Approval Drawings

ICF general arrangements, steel over ICF, elevations, sections and the questions for the engineer

Icf Homes - Dendrons

ISSUED	24.09.26
SHEETS	15
DRAWN BY	BuildEase

EQ-01 SF-S06 / SF-S08 bearings over the FF windows FF-WF02 / FF-WF19 (S-102, S-121)

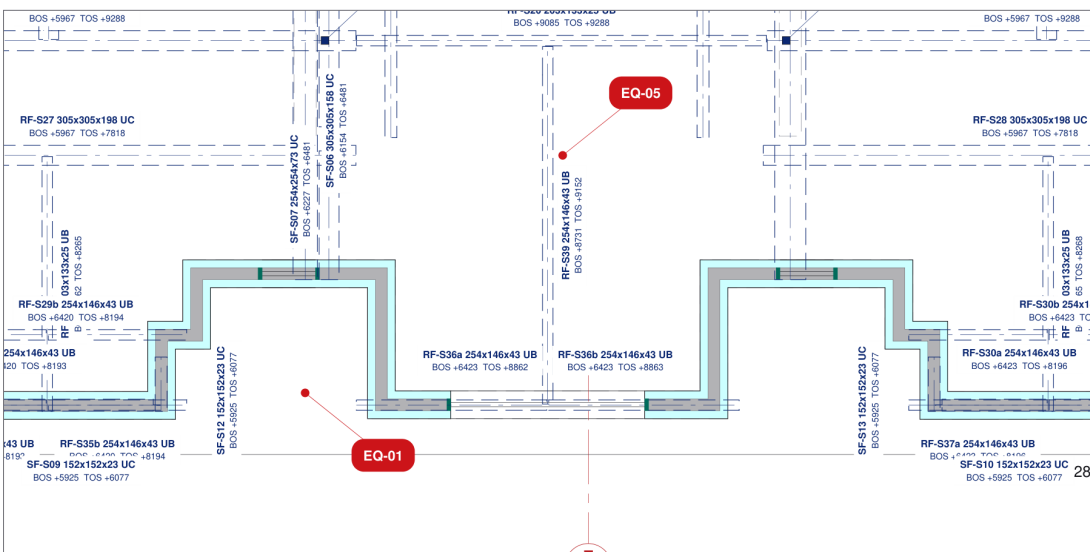
The second-floor transfer beams SF-S06 (UC 305x305x158, x 6370) and SF-S08 (UC 356x406x287, x 12586) bear on the south wall (L2, top 174.975 AOD) directly over the 685-wide FF windows either side of the entrance bay. At TOS 175.229 the beam undersides are 6252 (S06) and 6185 (S08) above the slab datum; the architect's window head is 6023, leaving 229 mm (S06) and 162 mm (S08) of wall between head and beam. S-121 schedules an RCB152 x 300 - 2H16 lintel there, which would reach 6323, 71 mm into SF-S06 and 138 mm into SF-S08.

Please confirm the bearing detail: a steel spreader under each beam end (model assumption UC 152x152x30, 1285 long, 300 bearing each side, TOS = beam underside), or a revised lintel / beam arrangement. The window positions are the architect's and are held.

EQ-02 Stair void on S-101 vs the architect's main stair (Plan FF, Sections A-A / E-E)

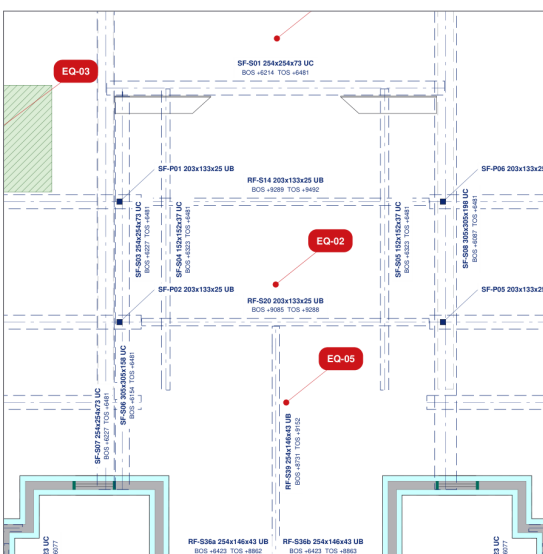
S-101 shows the stair void as the ellipse only (x 6.5..12.4 m, y 2.2..6.2 m) with a UC 203x203x46 trimmer on its north tangent (y ~6.23 m, TOS 171.950, "WALL BELOW") and hollowcore north of it. The architect's two curved flights (19 risers each) continue north beside a 3.3 m slot and land on the first floor at y ~8.9 m; that trimmer and the planks north of y 6.23 m would sit 1.1-1.5 m above the treads.

Please confirm the extent of the first-floor void (model: ellipse + flights + slot to y 8.93 m, planks HC-032/033/034 omitted, landing edge on the plank at y 8.89 m) and the trimmer arrangement around it.

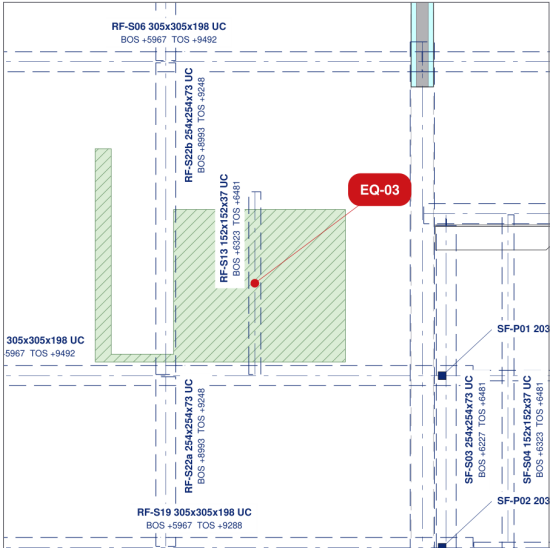
S-103 marks RF-S13 (UC 152x152x30; x 4225, y 7030..9373) as the LIFTING BEAM over the lift shaft; S-100 shows the shaft with UC 203x203x46 trimmers (2005 x 1925), S-101/S-102 the LIFT VOID and the STAIR VOID beside it, S-205 the blockwork shaft walls and the 200 pit recess. The model carries the blockwork shaft (walls x 3185..3385 / 5185..5385, y 7191..9145, 200 W/E, 100 N/S) and the secondary-stair enclosure west of it (x 2181..2385, y to y 9925) from the architect's plans, up to the underside of the roof plateau steel (178.240 TOS). RF-S13 is modelled at TOS 175.229 (the second-floor level) bearing on the shaft's N and S walls.

Please confirm the TOS of the lifting beam (175.229 as modelled, or at the roof plateau), its bearings on the blockwork shaft walls, the shaft wall thickness and the extent of the secondary stair (flight not modelled).

EQ-05 RF-S40 / RF-S41 bay ridge beams land 244 mm above RF-S27 / RF-S28

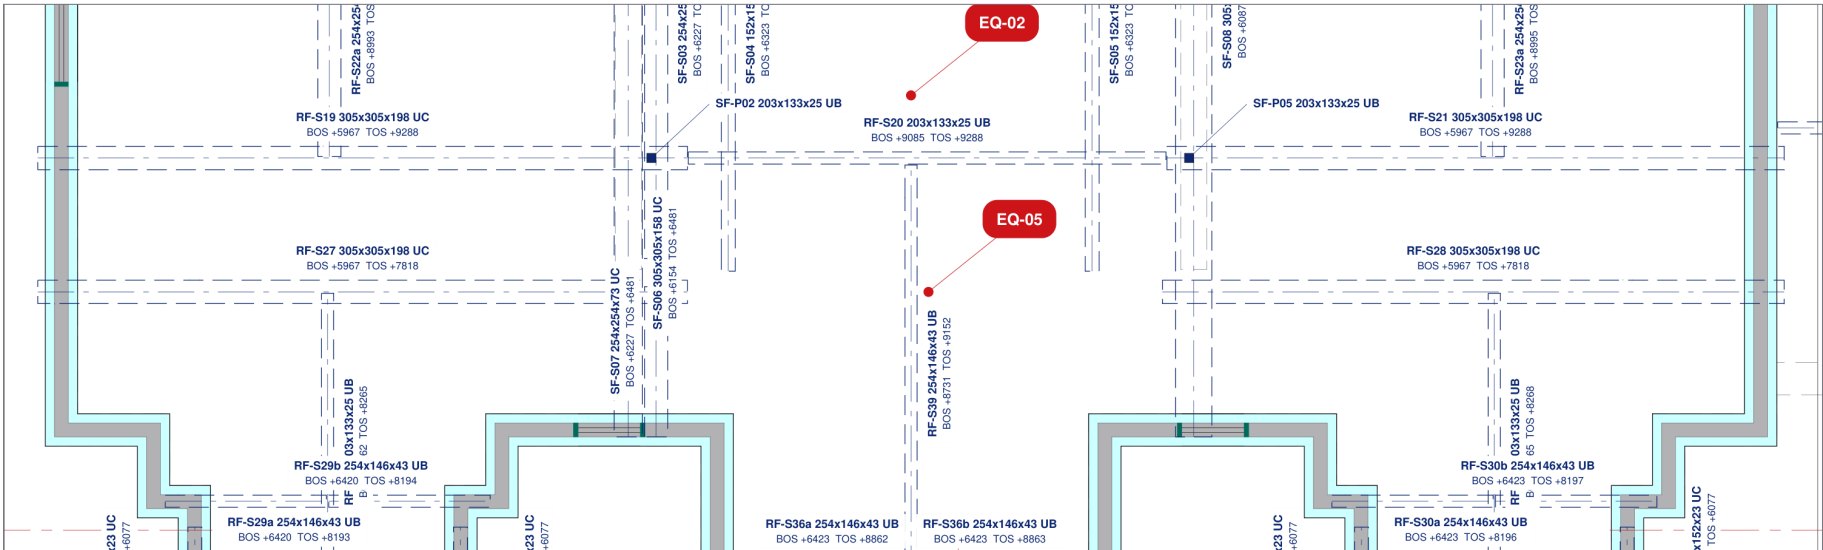
ISSUE RF-S40/RF-S41 (bay 1/3 ridge beams, TOS 177.013) land 244 mm above RF-S27/RF-S28 (TOS 176.566); modelled on 244-high stools.

QUESTION Please confirm the stool / seating detail.

EQ-06 Lintel depths vs the floor bearings (S-120 / S-121)

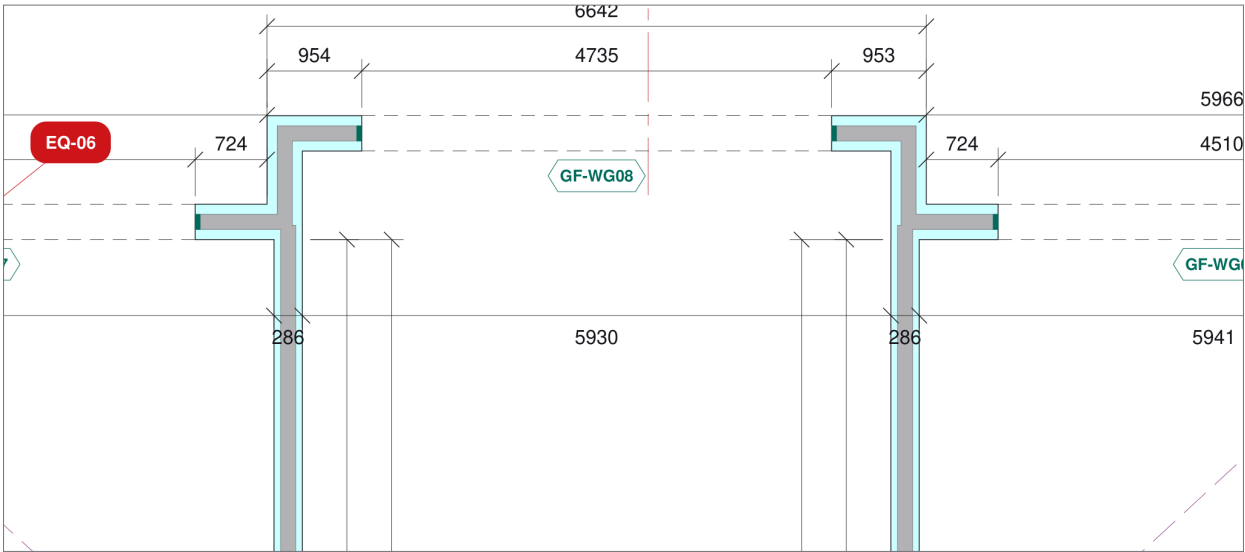
ISSUE GF north openings GF-WG07/08/09 (heads at 2948 = 171.598 AOD): the scheduled RCB152 x 375 - 2H20 reaches 3323, 23 mm above the hollowcore soffit 3300 (S-101 TOC 172.100, 150 planks). FF north windows FF-WF05/11 (heads 6023): the RCB152 x 350 - 2H20 reaches 6373, 48 mm above the FF wall top (174.975 AOD, the second-floor joist bearing). Both modelled as drawn. The pool-hall screens GF-WG10..13 carry the S-101 high-level beams FF-S16/S06/S07/S01 with no RC lintel.

QUESTION Please confirm the lintel / bearing arrangement at these openings.

EQ-07	S-120 internal ICF walls flanking the hall (x 6.2 m / 12.4 m) - door positions	Status: Open see GA-01
-------	--	--------------------------

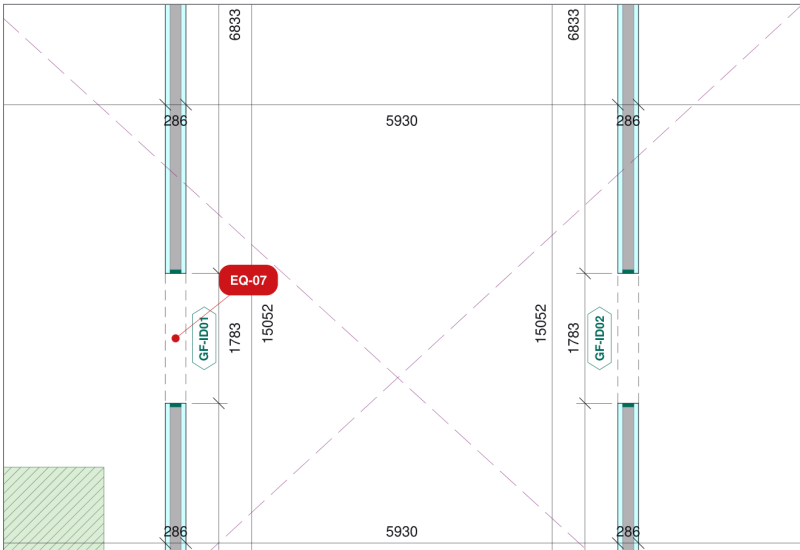
S-120 shows ICF 286 mm walls either side of the hall with lintels at y 10.0-11.8 m and (S-121) 12.7-13.6 m; the model has these walls (Walls 43/44) with double doors GF-ID01/02 (1783 wide) and FF doors FF-ID01/02 (915) from the architect's swings. S-120 also shows lintels on the annex cross wall (Wall 46) at x 21.6-22.8, 23.5-24.5 and 26.9-27.8 m and on Wall 47 at y 5.05-6.87 m; the architect's plan shows the Wall 46 doors at 23.5-24.5 and 26.85-27.8 m and single doors at the north ends of Walls 45/47. Modelled to the architect (GF-ID03..07).

Please confirm the door positions on the internal ICF walls.
